RESOLUTION MSC.75(69)  
(adopted on 14 May 1998)  
ADOPTION OF AMENDMENTS TO THE CODE ON INTACT  
STABILITY FOR ALL TYPES OF SHIPS COVERED  
BY IMO INSTRUMENTS (RESOLUTION A.749(18))

**ADOPTION OF AMENDMENTS TO THE CODE ON INTACT STABILITY FOR ALL TYPES  
OF SHIPS COVERED BY IMO INSTRUMENTS (RESOLUTION A.749(18))**

Figure 2.2.1

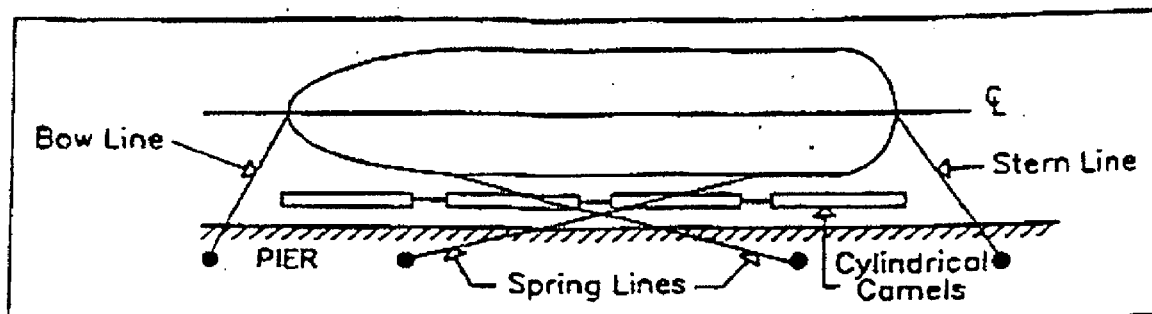
86 The existing text of section 2.2 "Mooring arrangements" is replaced by the following:

2.2.1 The mooring arrangement should ensure that the ship will be free to list without restraint for a sufficient period of time to allow a satisfactory reading of the heeling angle, due to each weight shift, to be recorded.

2.2.2 The ship should be held by lines at the bow and the stem, attached to bollards and/or cleats on the deck. If suitable restraint of the ship cannot be achieved using deck fittings, then temporary padeyes should be attached as close as possible to the centreline of the ship and as near the waterline as practical. Where the ship can be moored to one side only, it is good practice to supplement the bow and stern lines with two spring lines in order to maintain positive control of the ship, as shown in figure 2.2.1. The leads of the spring lines should be as long as practicable. Cylindrical camels should be provided between the ship and the dock. All lines should be slack, with the ship free of the pier and camels, when taking readings.

2.2.2.1 If the ship is held off the pier by the combined effect of the wind and current, a superimposed heeling moment will act on the ship throughout the test. For steady conditions this will not affect the results. Gusty wind or uniformly varying wind and/or current will cause these superimposed heeling moments to change, which may require additional test points to obtain a valid test. The need for additional test points can be determined by plotting test points as they are obtained.

2.2.2.2 If the ship is pressed against the fenders by wind and/or current, all lines should be slack. The cylindrical camels will prevent binding but there will be an additional superimposed heeling moment due to the ship bearing against the camels. This condition should be avoided where possible but, when used, consideration should be given to pulling the ship free of the dock and camels and letting the ship drift as readings are taken.

2.2.2.3 Another acceptable arrangement is where the combined wind and current are such that the ship may be controlled by only one line at either the bow or the stern. In this case, the control line should be led from on or near the centre line of the ship with all lines but the control line slack, the ship is free to veer with the wind and/or current as readings are taken. This can sometimes be troublesome because varying wind and/or current can cause distortion of the plot.
